IREDELL COUNTY HEALTH DEPARTMENT

IMPROVEMENT PERMIT / AUTHORIZATION TO CONSTRUCT / OPERATION PERMIT / EXISTING SYSTEM INSPECTION

PERMIT# 123253 PIN# 4664670278.002 9664-68-0192 DATE 4/15/05

SUBDIVISION ANNISTON BLOCK / SECTION 1 LOT 2 LOT AREA 1.32Ac SITE CLASS. PS DESIGN FLOW 480GPD L.T.A.R. .25 GPD/FT2

AS BUILT SKETCH

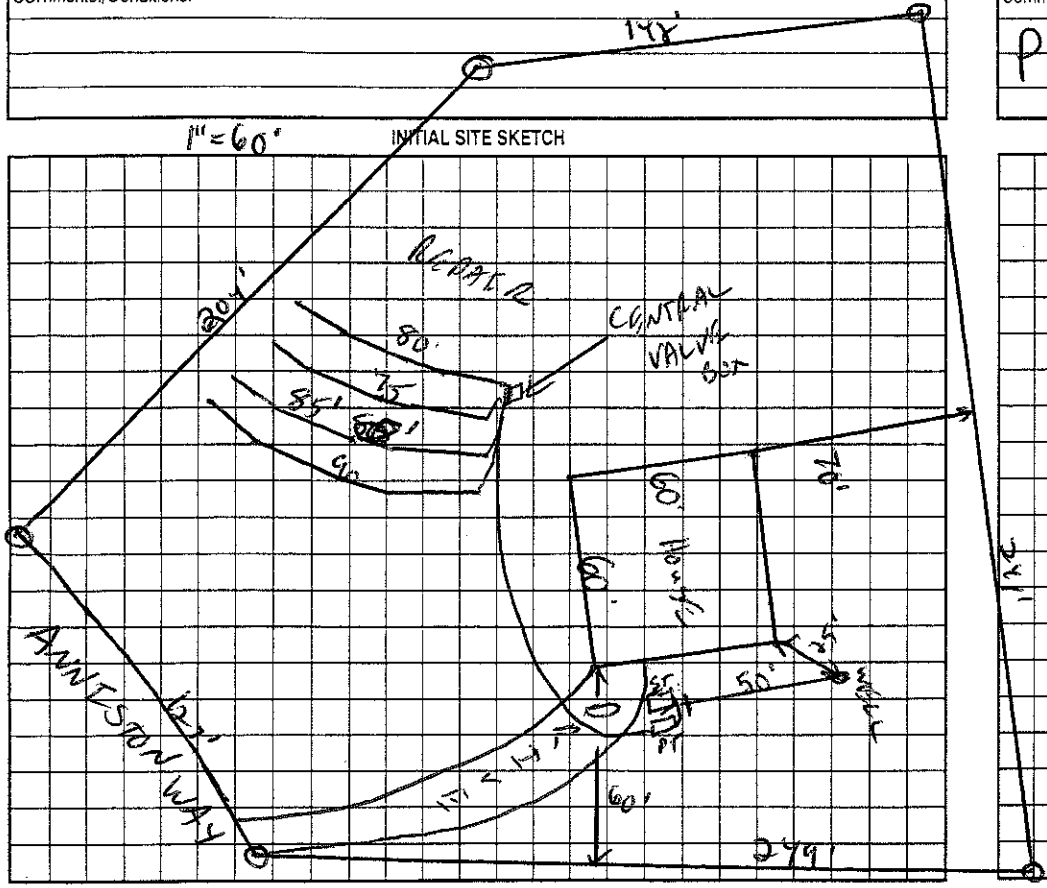
Comments:/Conditions: Reviewed Building plans & site plan; essentially in compliance with I.P.

-4 lines (Panel) installed @ 75' each due to pre-grading of site causing steep ~10' embankment side sloping towards driveway

-Installer left 15' between trenches and side slope; if any further cutting/shaving of embankment after final grading for landscaping etc, then permit will be revoked no room to spare
